No. EC155-25A160

ALERT SERVICE BULLETIN

EQUIPMENT AND FURNISHINGS - Main Rotor Flight Controls
Check of the shear-button safety-cap on the collective pitch handle

Revision No.	Date of issue
Revision 0	2022-10-04

Figure 4 - Fully close position of the safety-cap

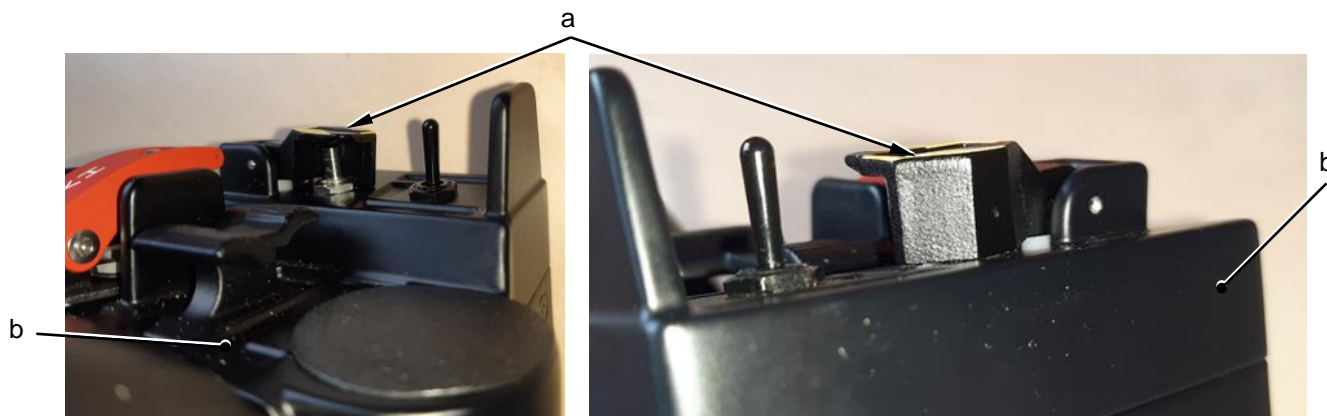
- Make sure that the safety-cap (a) on the collective pitch handle (b) is in the fully closed position, refer to Figure 4.

Figure 5 - Position of the thumb

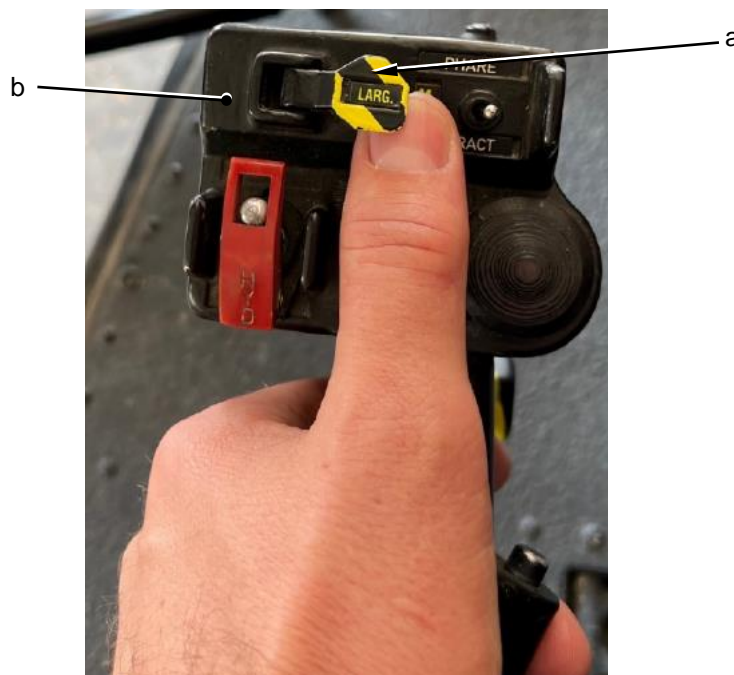
- Put the thumb below the safety-cap (a) of the collective pitch handle (b), refer to Figure 5.

Figure 6 - Step1

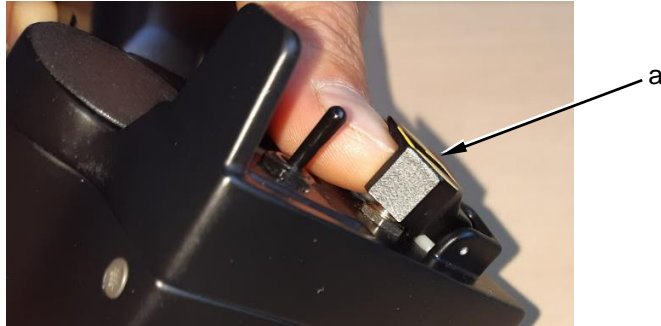
- Do the steps that follow to do the check of the safety-cap (a):
 - . Put the thumb below the safety-cap (a).
 - . Lift the safety-cap (a) with your thumb, refer to Figure 6.
 - . Remove the thumb.
 - . Make sure that the safety-cap (a) go back to the fully closed position or move to the fully open position.
 - . If necessary close the safety-cap (a).

Figure 7 - Step2

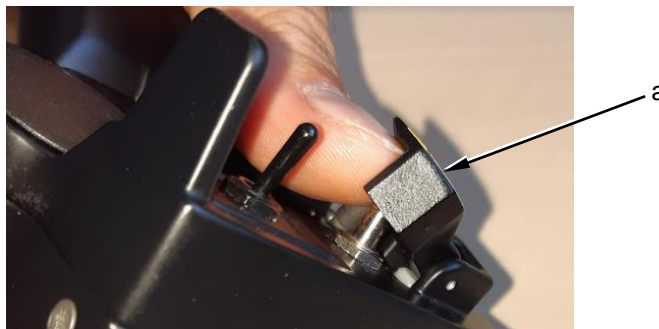
- . Put the thumb below the safety-cap (a).
- . Lift the safety-cap (a) with your thumb, refer to Figure 7.
- . Remove the thumb.
- . Make sure that the safety-cap (a) goes back to the fully closed position or moves to the fully open position.
- . If necessary close the safety-cap (a).

Figure 8 - Step3

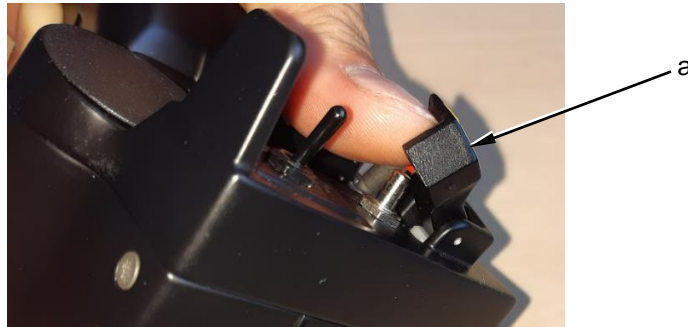
- . Put the thumb below the safety-cap (a).
- . Lift the safety-cap (a) with your thumb, refer to Figure 8.
- . Remove the thumb.
- . Make sure that the safety-cap (a) goes back to the fully closed position or moves to the fully open position.
- . If necessary close the safety-cap (a).

Figure 10 - Replacement of the spring of the safety-cap

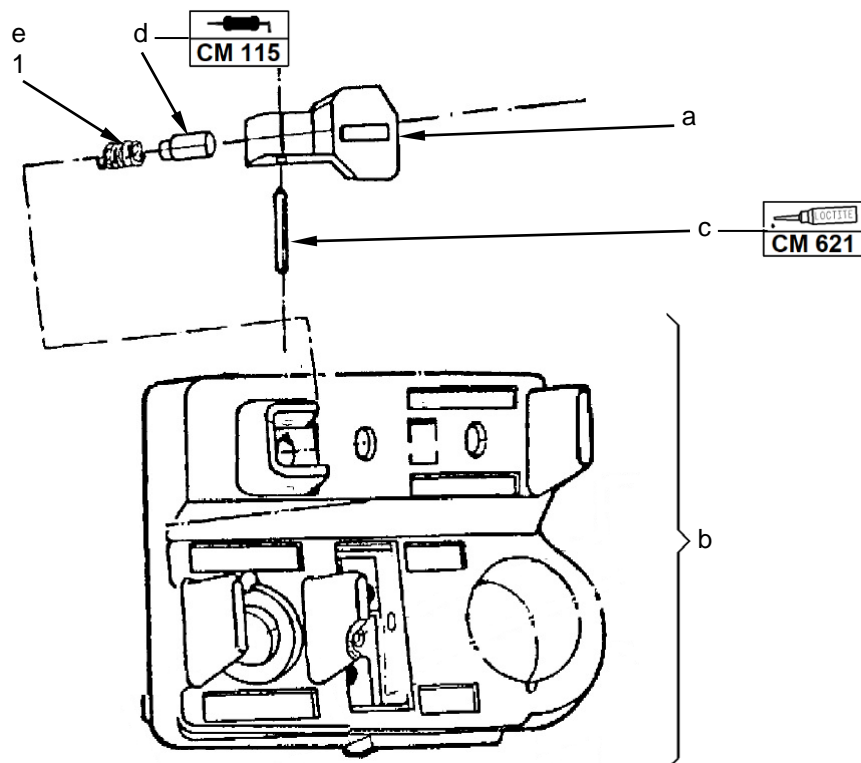
3.B.3. Replacement of the spring of the safety-cap ([Figure 9](#) and [Figure 10](#))

THE SPRING (e) AND THE PUSH ROD (d) CAN BE EJECTED DURING THE REMOVAL PROCEDURE.

- Removal of the safety-cap (a):
 - . Remove the pin (c) from the collective pitch handle (b).
 - . Remove the safety-cap (a).
 - . Remove the push rod (d) and the spring (e).
 - . Discard the spring (e).

- Installation of the safety-cap (a):
 - . Apply grease (3) to the push rod (d).
 - . Put the new spring (1) and the push rod (d).
 - . Install the safety-cap (a) with the pin (c).
 - . Lock the pin (c) with locking compound (2).
 - . Make sure that the open and closed positions of the safety-cap (a) are correct:
 - .. Move the safety-cap (a) three times minimum.
 - .. Make sure that it is free to move.
